City of
Richmond

Report to Development Permit Panel

Re: **Application by GBL Architects for a General Compliance Ruling at
6551 No. 3 Road**

That the attached plans involve changes to the design of the first phase of the CF Richmond Centre mixed-use development at 6551 No. 3 Road, incorporating voluntary artworks to screen above-grade parking and equipment, introduce Retail Tenant Storefronts Design Guidelines for tenant improvements and adjust surplus parking, are considered to be in General Compliance with Development Permit (DP 17-768248).

DP 17-768248
 AUG 26, 2024
PLAN # 11f-1

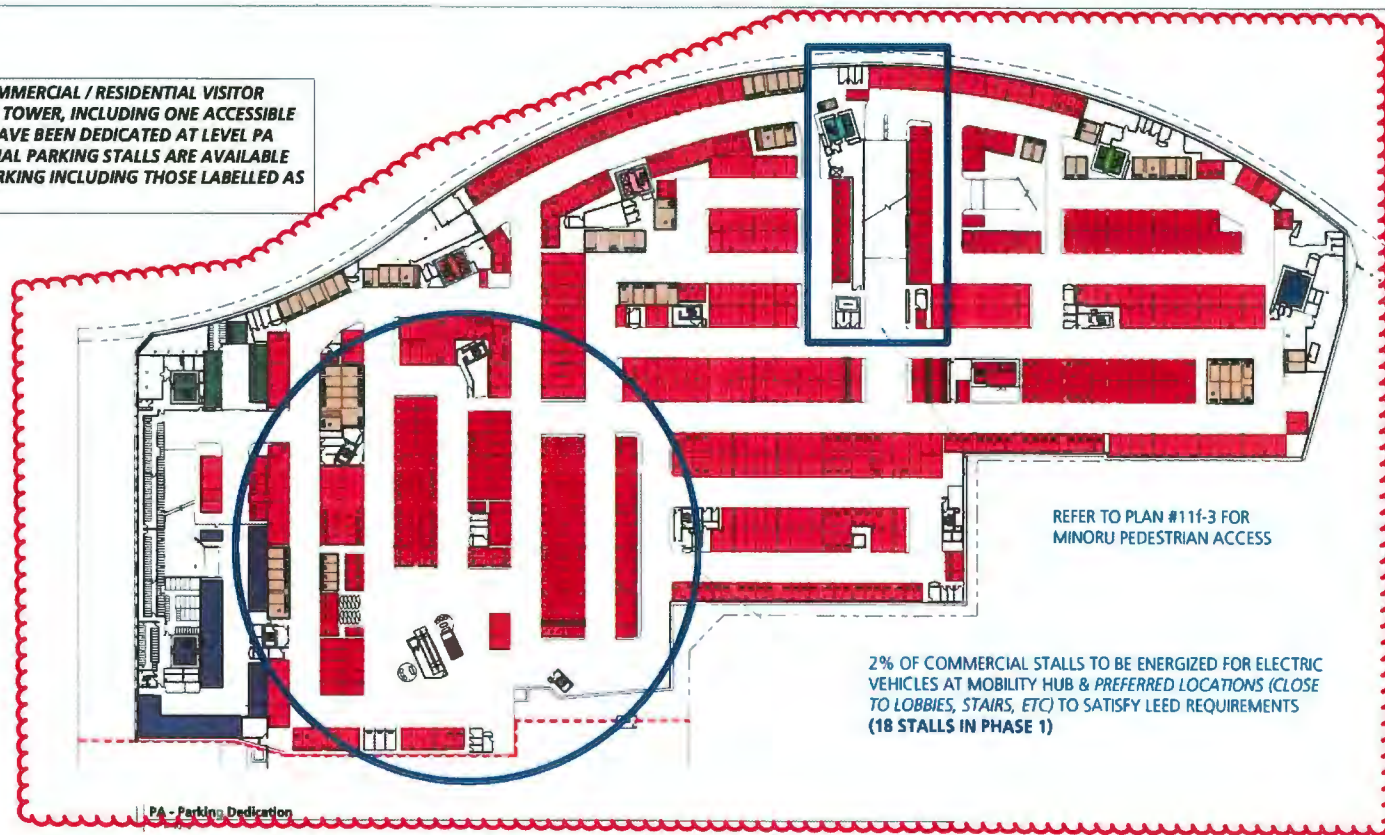
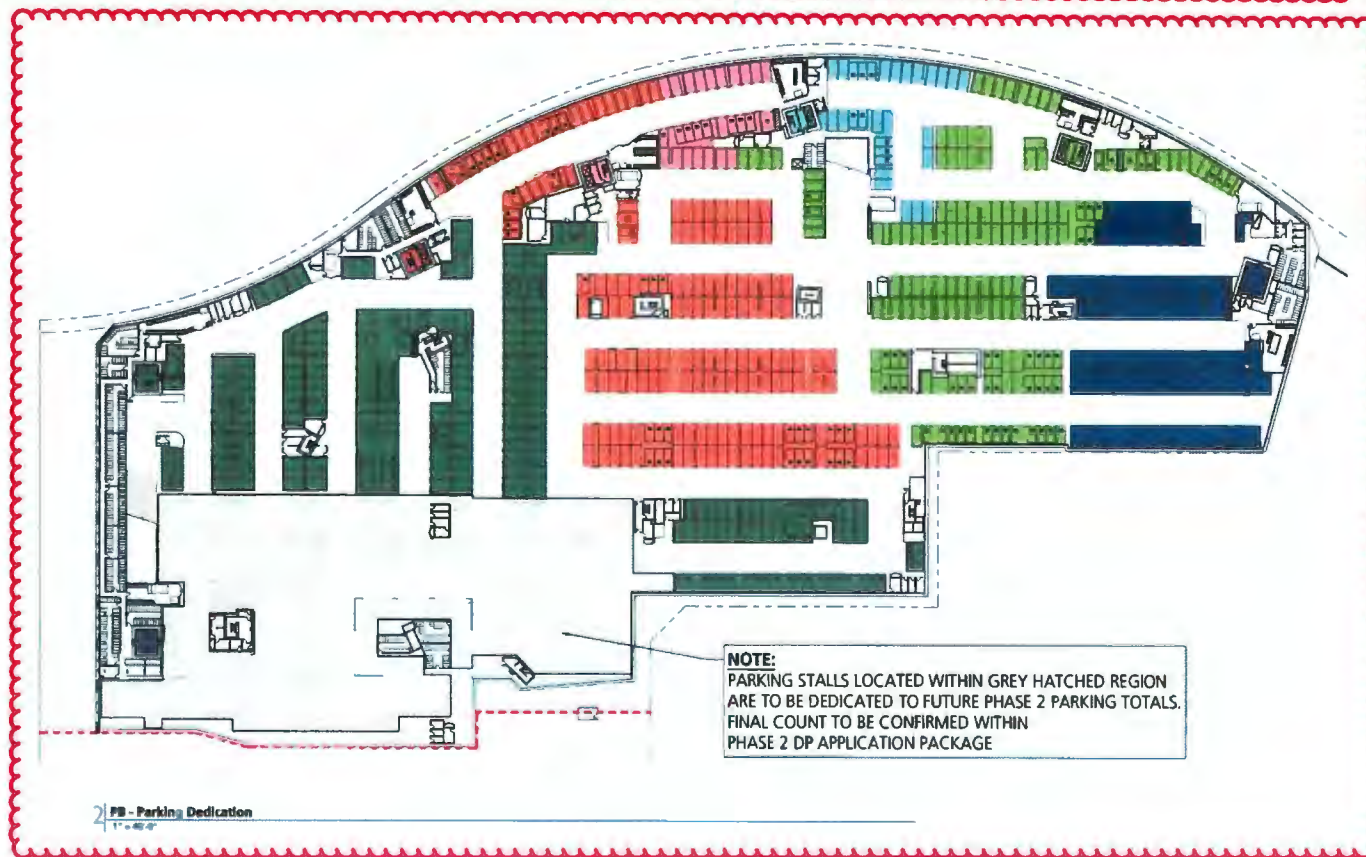
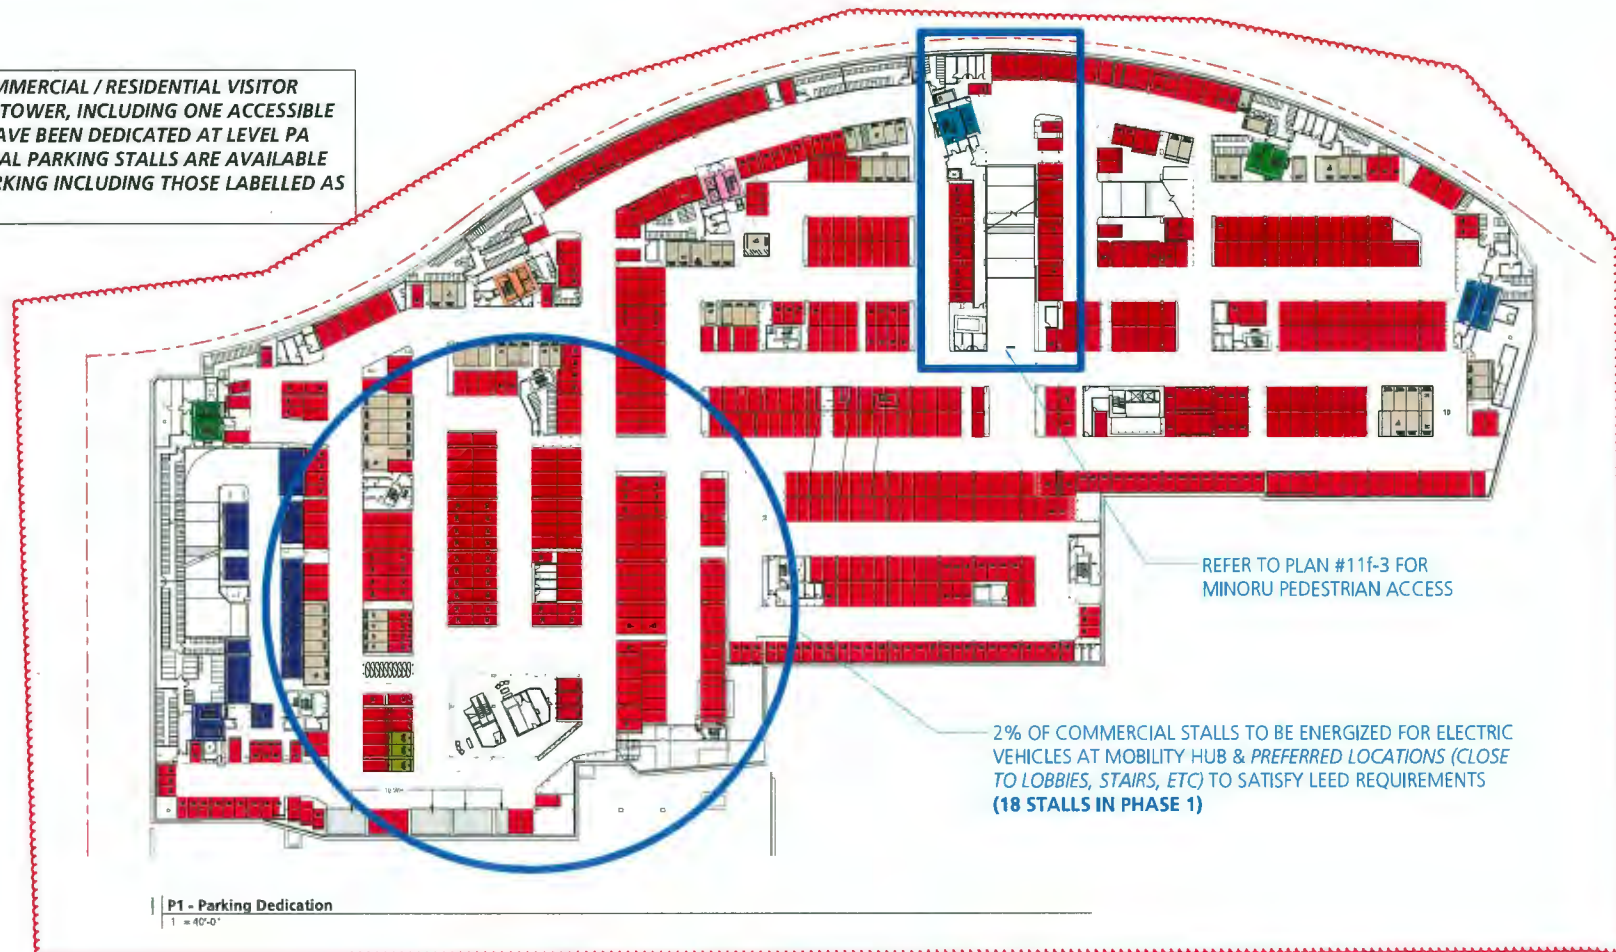
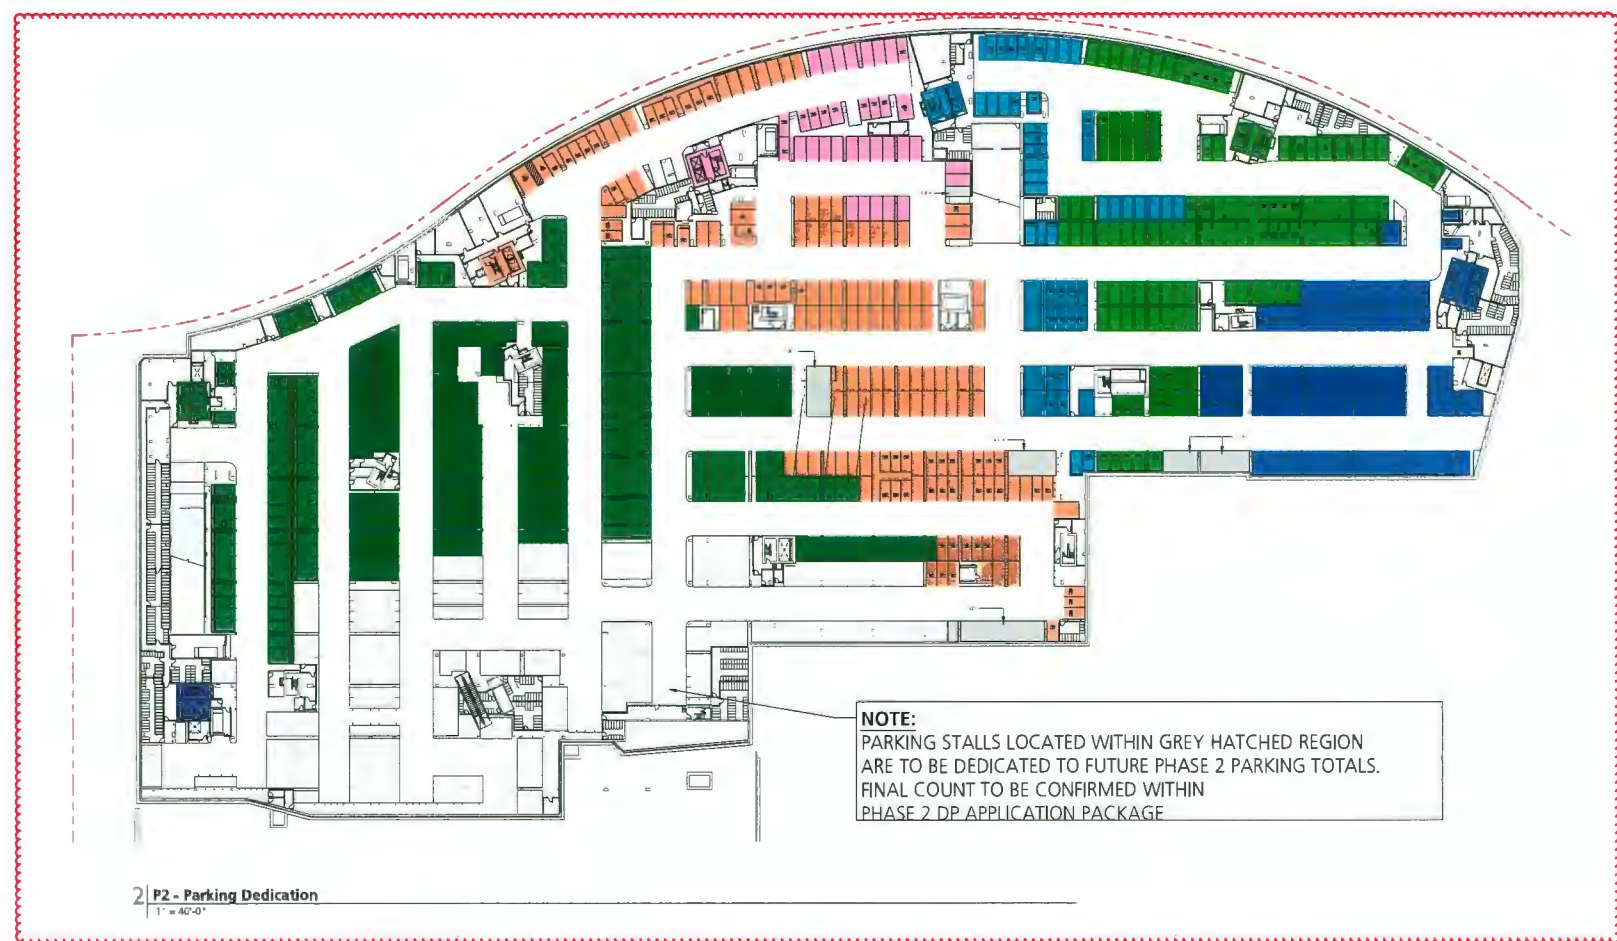
Minor changes required during the construction of Phase One have resulted in an overall reduction of 62 parking spaces on the Phase One site. The developer is proposing to address the change in parking by reducing the number of parking spaces provided for Phase One market strata by 30 spaces. Further, an allocation of spaces that had previously been designated as Phase One surplus parking, for Phase Two residential and commercial uses has been reduced by 32 spaces. The developer has proposed to increase the total number of stalls to be constructed in Phase 2 by 32 stalls to offset the reduction in parking on Phase 1. The Phase 2 development permit is subject to a future report and consideration by the Development Permit Panel.

- reducing the Phase One market strata parking by 30 spaces (i.e. from 1,155 approved to 1,125);
- reducing the future Phase Two residential parking by 17 spaces (i.e. from 192 approved to 175); and
- reducing future Phase Two commercial parking by 15 spaces (i.e. from 31 approved to 16).
